PRODUCT BULLETIN

04 to 05 Design Level

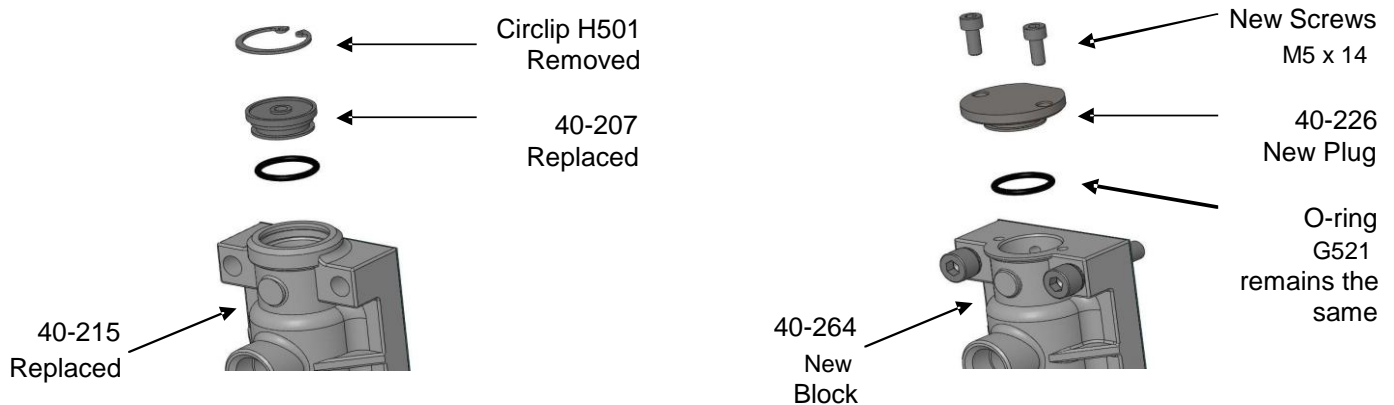
BD Pump are committed to the continuous improvement of our product and service and with this in mind we are introducing new Valve Blocks and Valve Block Plugs to the range.

The traditional 'BD' Valve Block has always been considered a strength of the BD pump. Its simplicity, design and ease of maintenance has always been regarded as a significant strong point in the success of the pump. To bring in line with other models we are improving the design by removing the circlip on the B25 & B40 models and replacing this with a new plug retained with socket cap head screws. This change brings the design in line with the B06 and B15 models to standardise the range.

The new Valve is totally inter-changeable with any previous model and also available as a replacement spare assembly :- SA10585
